Project	<b>IEEE 802.16 Broadband Wireless Access Working Group</b> < <a href="http://ieee802.org/16">http://ieee802.org/16</a> >	
Title	Text Clarification and Clean-up for the MAC Header	
Date Submitted	<b>2005-05-04</b>	
Source(s)	Hang Zhang, Mo-Han Fong, Peiying Zhu, Wen Tong Nortel Networks	<a href="mailto:mhfong@nortelnetworks.com">mhfong@nortelnetworks.com</a>
	Sean Cai, Mary Chion ZTE San Diego	<a href="mailto:scai@ztesandiego.com">scai@ztesandiego.com</a>
	Yongseok Jin, Bin-Chul Ihm, Jin Young Chun, Ki-seon Ryu LG Electronics. Inc.	<a href="mailto:jayjay@lge.com">jayjay@lge.com</a>
	Jung-je Son, Hyunjeong Kang Samsung Electronics	<a href="mailto:jungje.son@samsung.com">jungje.son@samsung.com</a>
	Lei Wang Cygnus Communications Inc.	<a href="mailto:lwang@cygnuscom.com">lwang@cygnuscom.com</a>
	Rainer Ullmann Wavesat	<a href="mailto:rullmann@wavesat.com">rullmann@wavesat.com</a>
	Vladimir Yanover, Tal Kaitz Alvarion	<a href="mailto:vladimir.yanover@alvarion.com">vladimir.yanover@alvarion.com</a>

Re:	IEEE P802.16e/D7-2005
Abstract	This contribution provides text clarification and clean-up regarding the MAC header
Purpose	Review and Adopt the suggested changes into P802.16e/D7

**Figure 19a—MAC signaling header type I format**

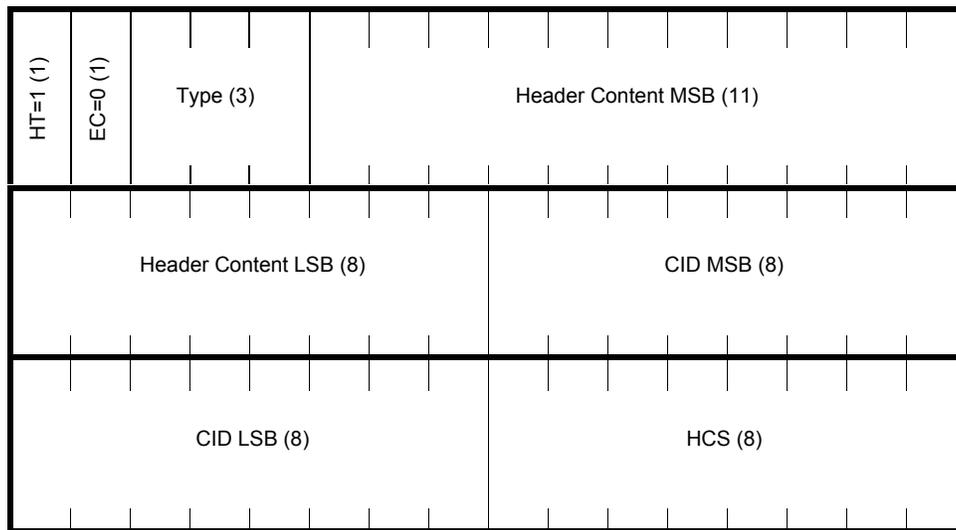
For this MAC header format, there is no payload following the MAC header. The MAC signaling header type I is illustrated in Figure 19a. Table 5a describes the encoding of the 3-bit type field following the EC field.

*[Insert the following figure]*

**Figure 20c— CQICH Allocation Bandwidth request**

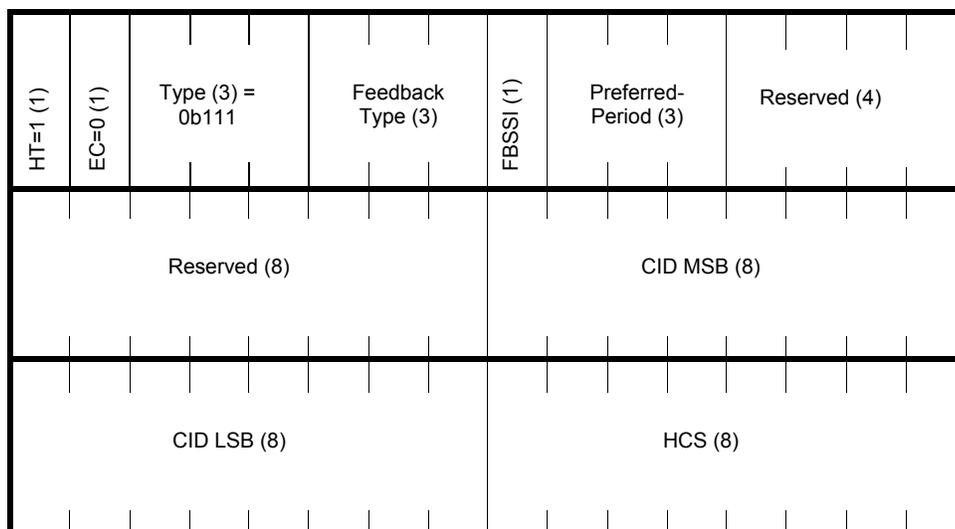
*[Replace Figure 20c with the following drawing]*

The CQICH allocation request header shall have the following properties:

- a) The length of the header shall always be 6 bytes.
- b) The EC field shall be set to 0, indicating no encryption.
- c) The CID shall indicate the MS basic CID.
- d) The Type field shall be 0b111.

**Figure 20d—PHY channel report header**

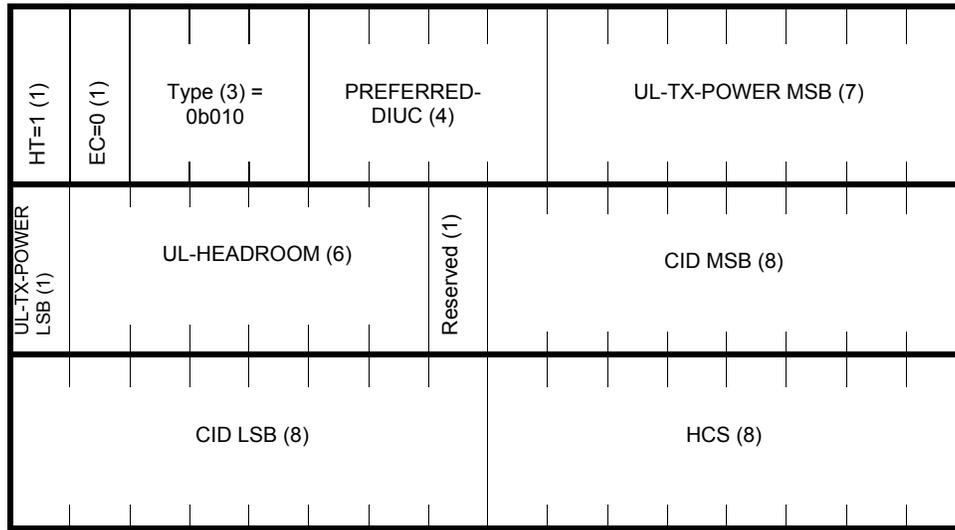
*[Replace Figure 20d drawing with the following drawing, to ensure consistency in all headers' drawing format]*

The PHY channel report shall have the following properties:

- a**e) The length of the header shall always be 6 bytes.
- b**f) The EC field shall be set to 0, indicating no encryption.
- c**g) The CID shall indicate the MS basic CID.
- d**h) The TYPE field shall be 0b010.

**Figure 20e—Bandwidth request and uplink sleep control header**

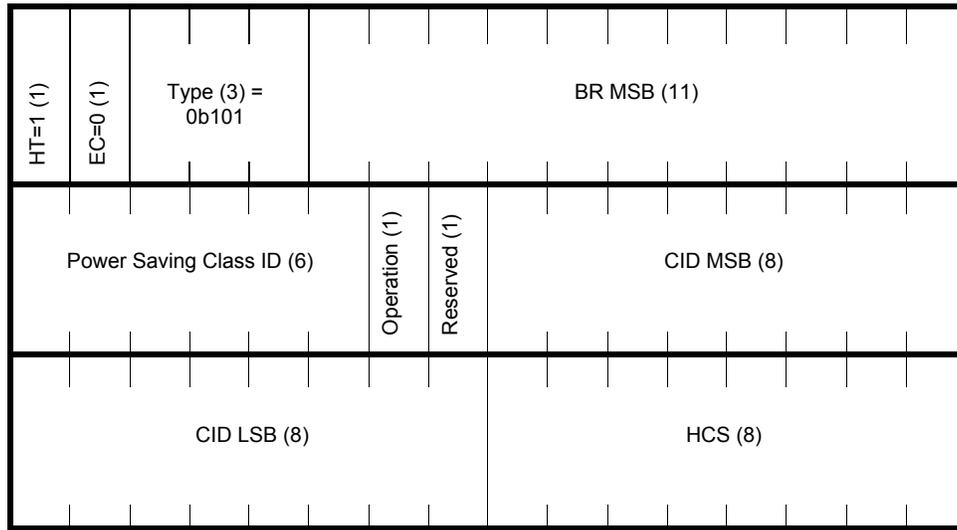
[Replace Table 7e by a new Figure and Table below, so as to be consistent with other header description]

The Bandwidth request and uplink sleep control header shall have the following properties:

- a The length of the header shall always be 6 bytes.
- b The EC field shall be set to 0, indicating no encryption.
- c The CID shall indicate the MS basic CID.
- d The TYPE field shall be 0b101.

**Figure 24a20f—SN report header format**

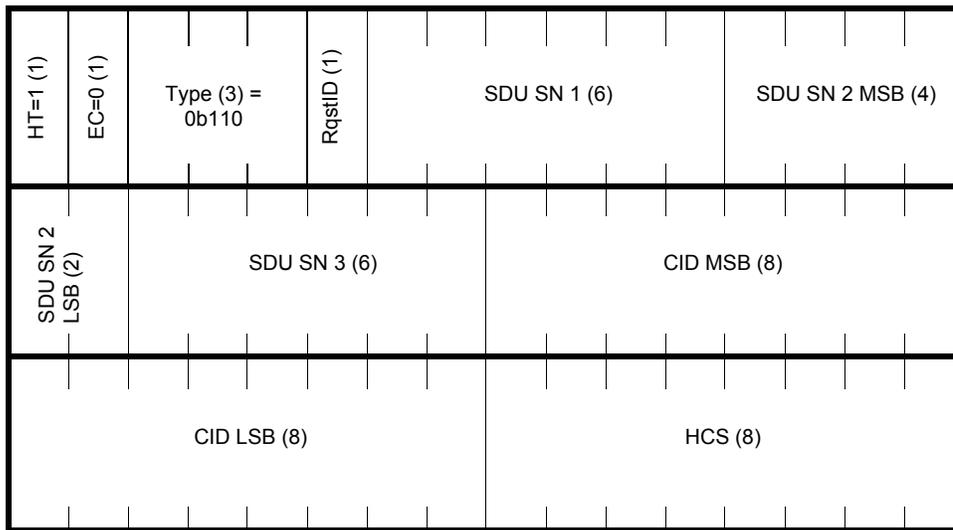
*[Replace Figure 21a drawing with the following drawing to ensure consistency in headers' drawing format.]*

The SN Report Header shall be of the form illustrated in Figure 24a20f. The SN Report header shall have the following properties:

- The length of the header shall always be 6 bytes
- The EC field shall be set to 0, indicating no encryption
- The CID shall indicate the basic connection of the MSS for which the SN Report is being sent.

**Figure 20g— MAC signaling header type II format**

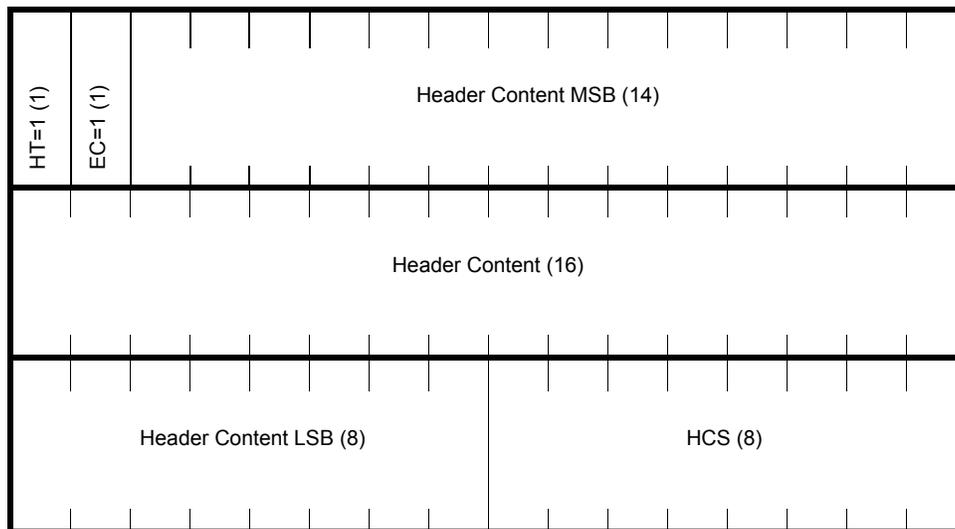
**6.3.2.1.2.2 MAC signaling header type II**

**Figure 20-bh** — Feedback header with CID field

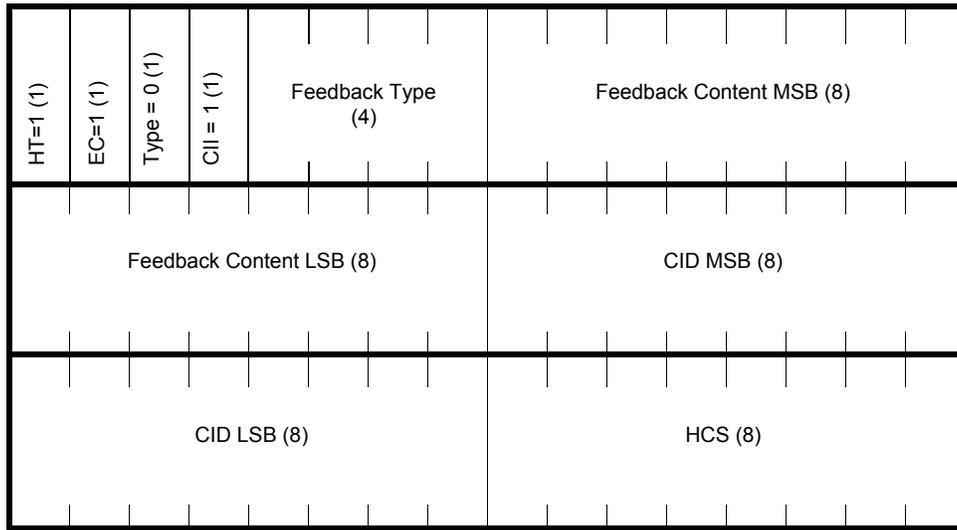
*[Replace drawing in Figure 20b in p802.16e/D7 with the following drawing to ensure consistency]*

**Figure 20-ej** — Feedback header without CID field

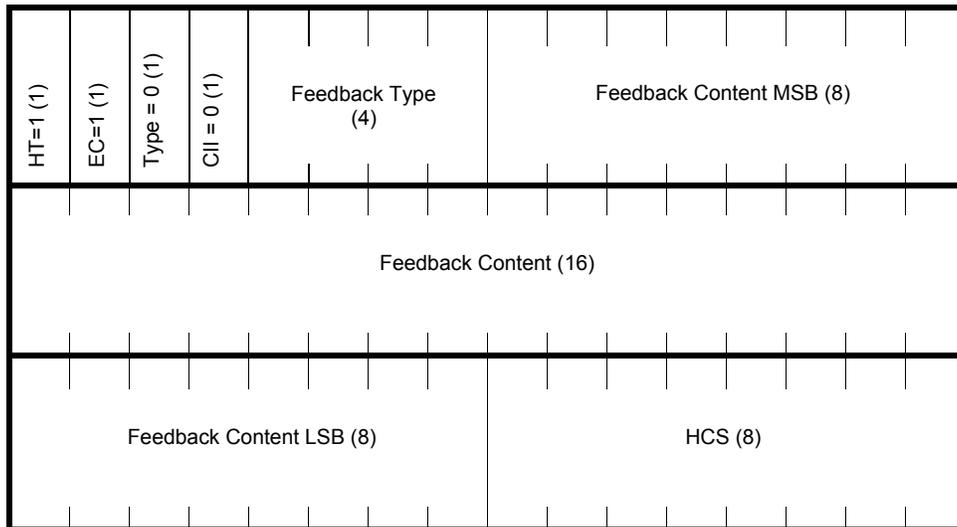
*[Replace drawing in Figure 20c in p802.16e/D7 with the following drawing to ensure consistency]*

**Figure 20ej — MIMO Channel Feedback header with CID field**

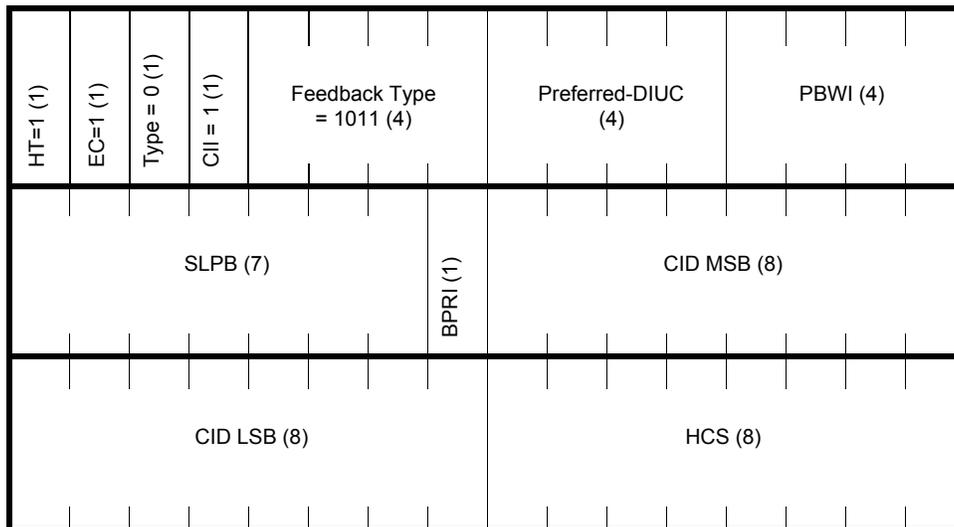
[Replace drawing in Figure 20e on page 28 in p802.16e/D7 with the following drawing]

Figure 20fk — MIMO Channel Feedback header without CID field

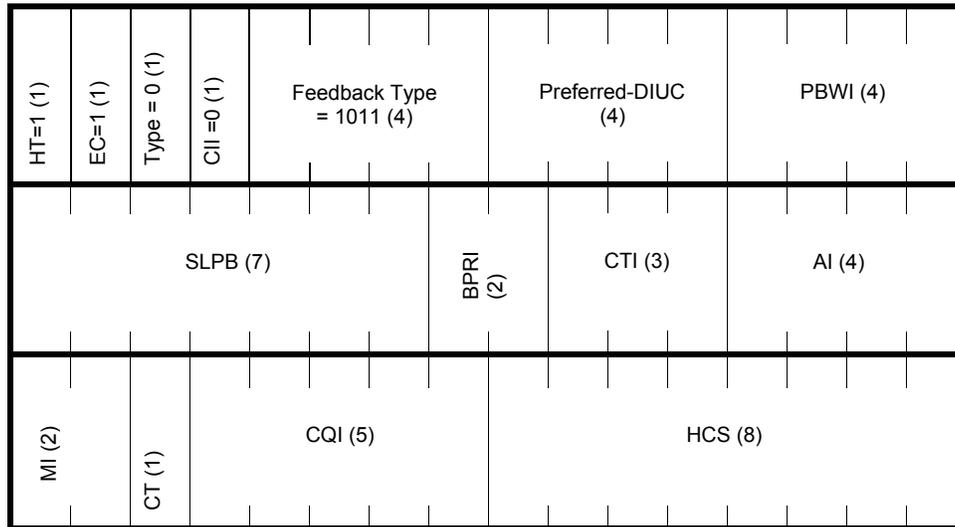
[Replace drawing in Figure 20f on page 28 in p802.16e/D7 with the following drawing]
